SERVICE BULLETIN

Title: XT Series Battery Protection / Mast Cam Handle Wire

Identification	SB-006
Status	Active
Issue	1
Issue Date	17 April 2007
Applicability	XT 912, serial numbers 001 to 0169 inclusive XT 582, serial numbers 001 to 0040 inclusive unless previously accomplished.
Compliance	Optional

Figure 1
Correct Routing
For wing fitting

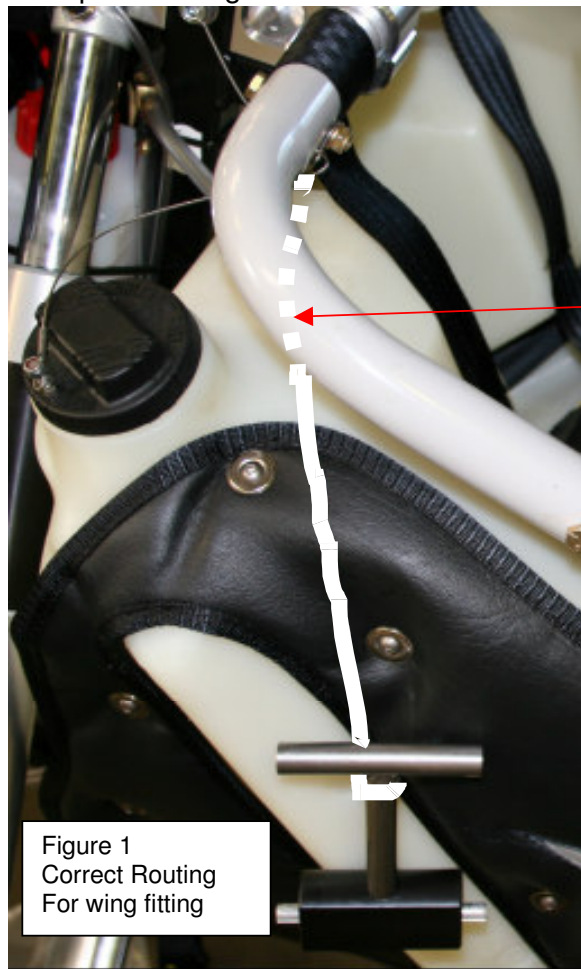
Mast folded For Fitment of Wing

Handle Position and Cable Routing

1. The cable is routed underneath the seat frame.
2. The handle is placed outside of the aircraft.

as depicted in Figure 1.

Cable UNDER seat frame

Figure 2
Correct Routing
Flight condition

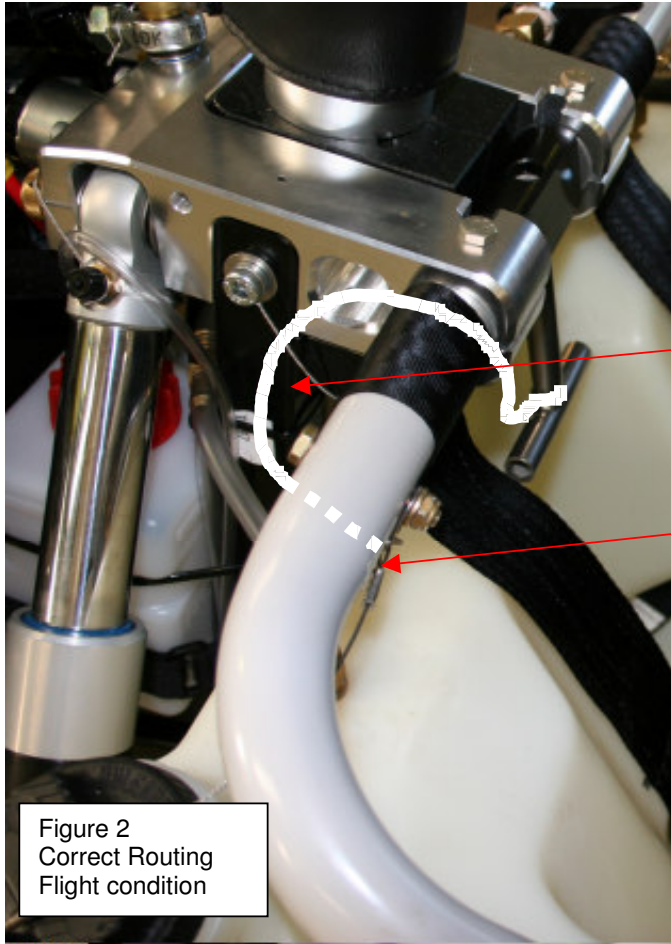
Mast Fastened for Flight

Handle Position and Cable Routing

1. The cable is routed underneath and around the rear of the seat frame.
2. The handle is placed in the slots.
3. The handle is rotated downwards into the locked position.

as depicted in Figure 2.

Cable around the back of and OVER seat frame

Cable UNDER seat frame

Figure 3
Mast Folded
Handle Stowage

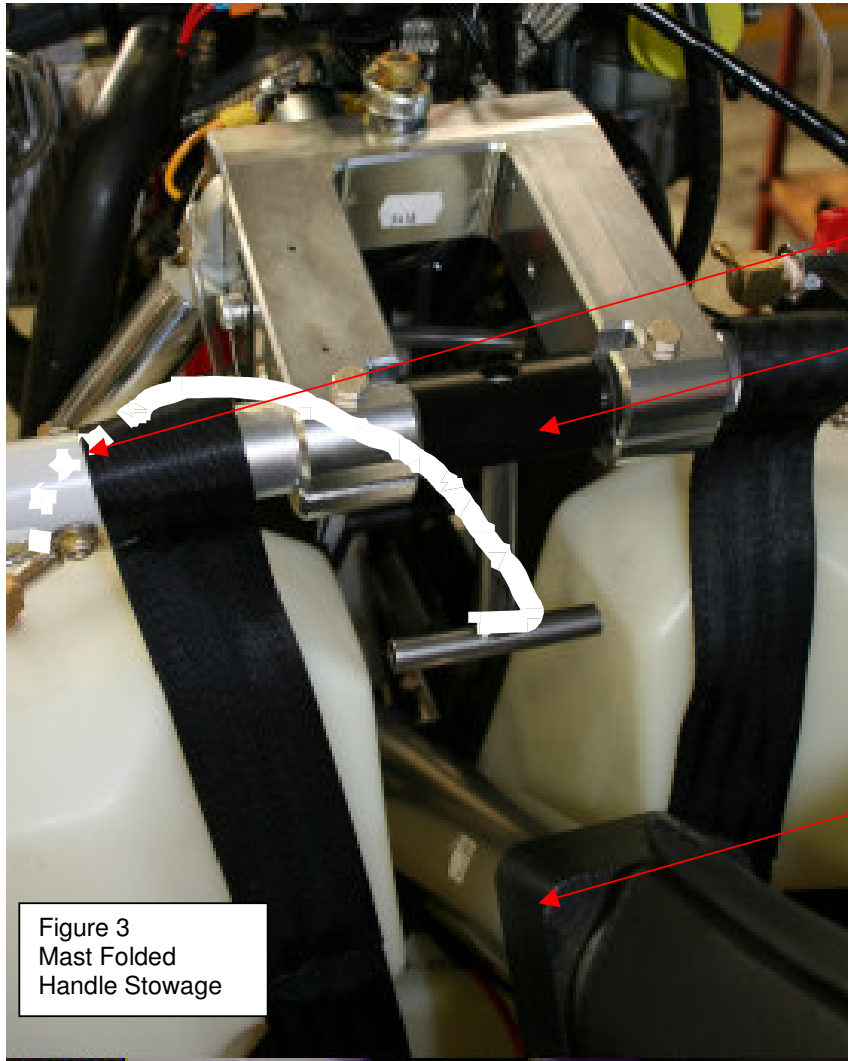
Mast Folded for Transport

Handle Position and Cable Routing

1. The cable is routed underneath and around the rear of the seat frame.
2. The handle is placed in the slots to hang.

as depicted in Figure 3.

Cable UNDER seat frame, then around the rear of the seat frame.

Handle stowed in the mast cam handle slots

Mast Folded for transport
